Tully BESS (SARA ref. 2606-52803 SDA) – Applicant Response to Information Request

We act on behalf of the applicant, RWE Tully Battery Pty Ltd, and write in response to the letter dated 3 July 2026 setting out the State Assessment and Referral Agency (SARA) request for further information for the proposed Tully BESS project (SARA ref. 2606-52803 SDA). A copy of the letter is provided at **Attachment 1**.

DWG No: RWE-002-043[D]
 - Figure 1.0 - Proposed
 Access to OHTL
DATE: 26/08/2026
DRAWN: JM
REVIEWED: EJ

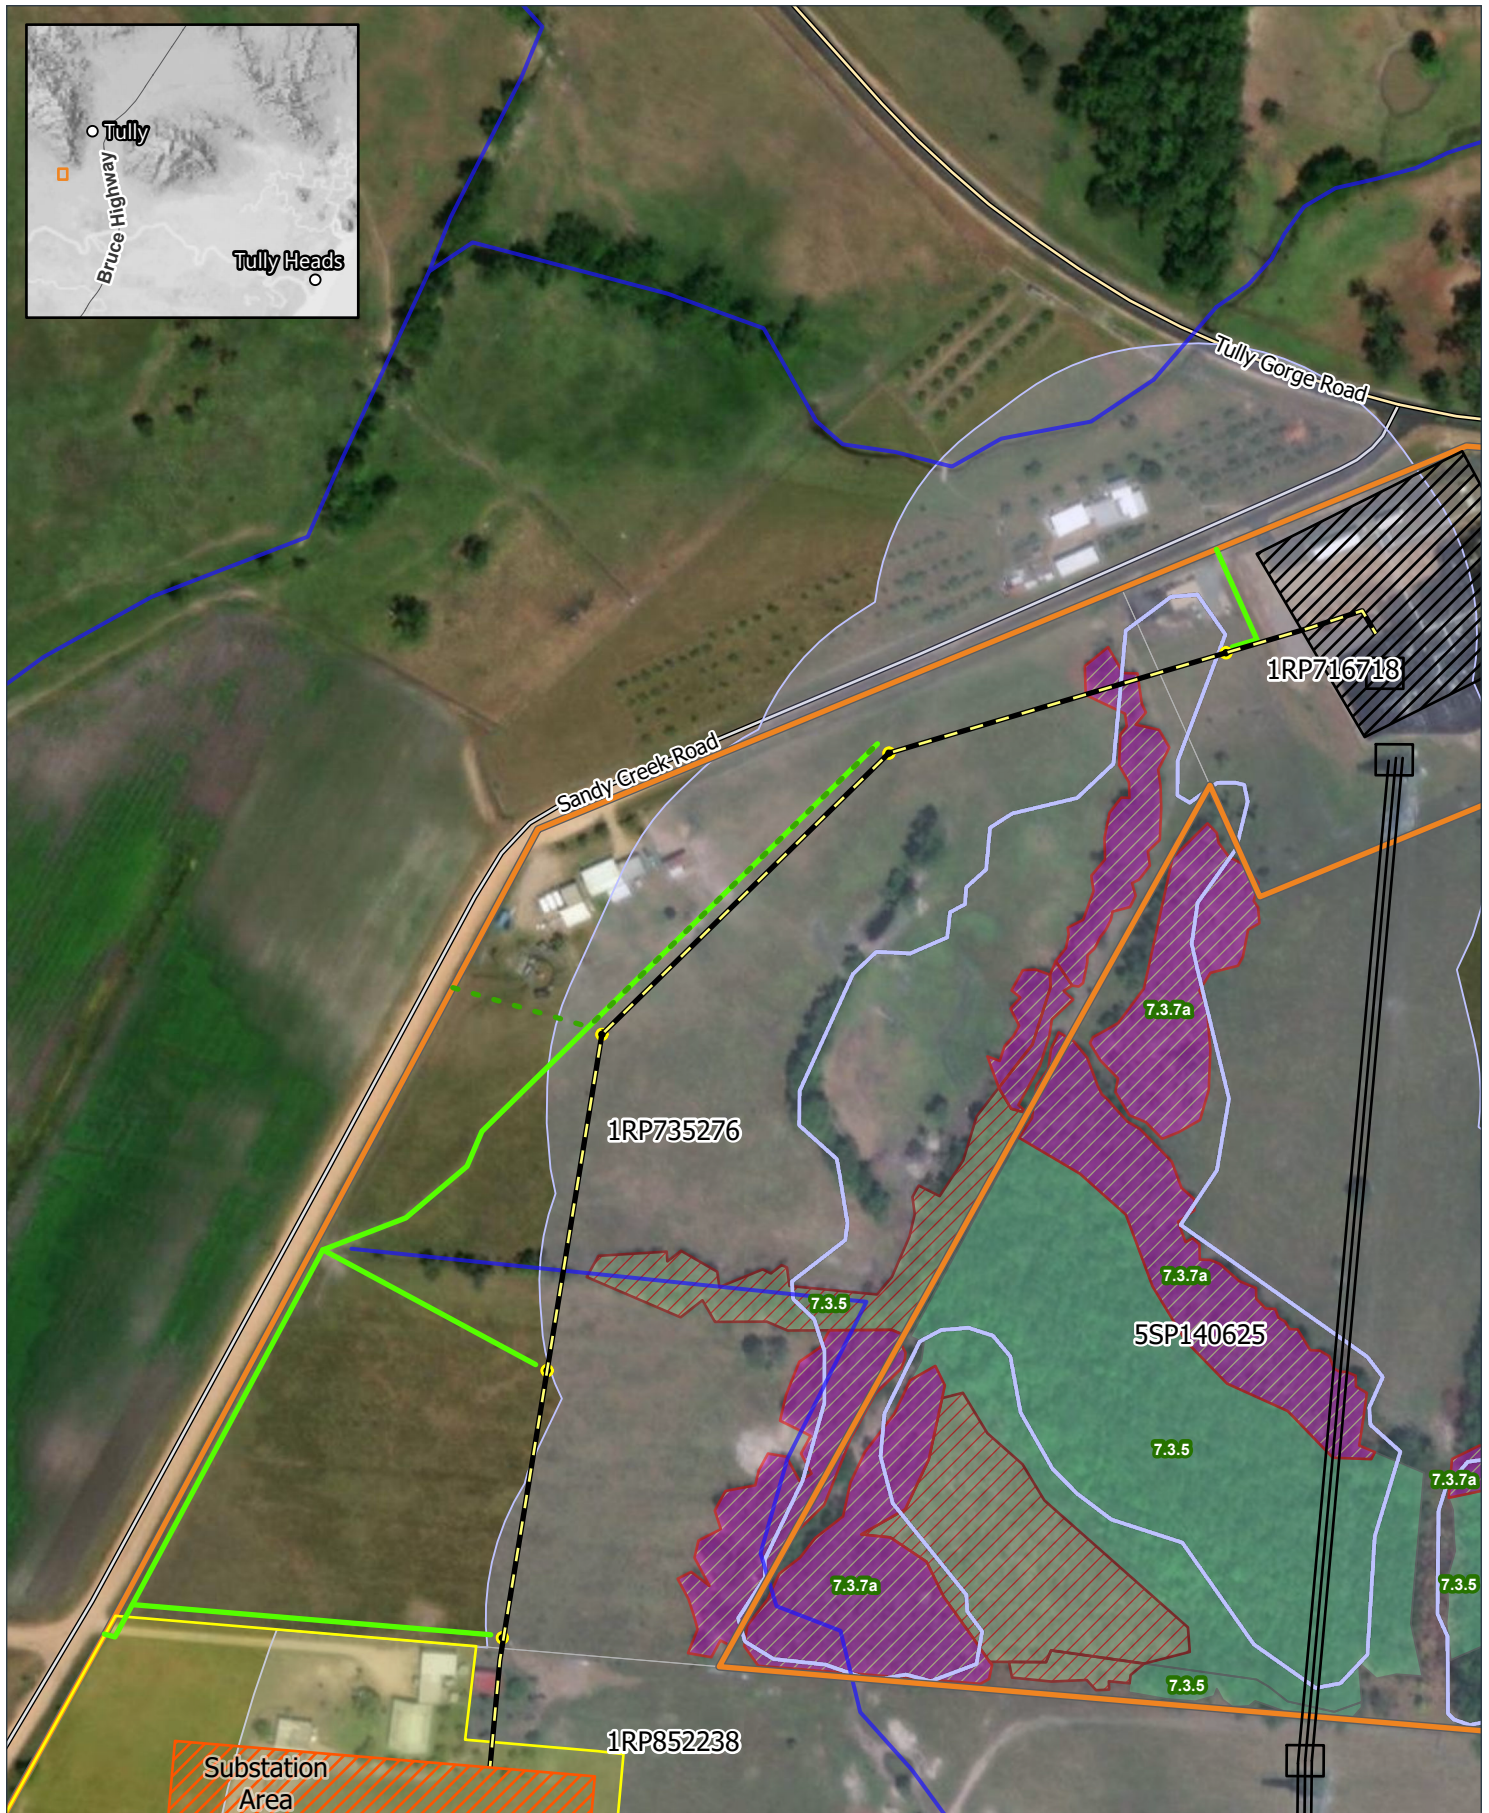
- b) Provide a revised plan clearly showing the location of the proposed access track for the OHTL.

The northern support pole associated with the OHTL avoids areas of high ecological value, including the mapped high ecological significance (HES) wetland, as shown in **Attachment 4**. The pole is located over 30 m from the nearest mapped vegetation in the ground-truthed regional ecosystem (GTRE) map and within the lot/plan of the existing substation. The next support pole to the west is also outside the mapped HES wetland with a separation distance of over 40 m.

A revised plan showing the indicative location of the proposed access tracks for the OHTL is shown as **Attachment 4**. The revised plan also shows support pole locations associated with the OHTL. The access tracks and OHTL poles avoid impacts to areas of high ecological significance as discussed above in the response part (a). The final locations of access tracks and support poles will be confirmed through detailed design.
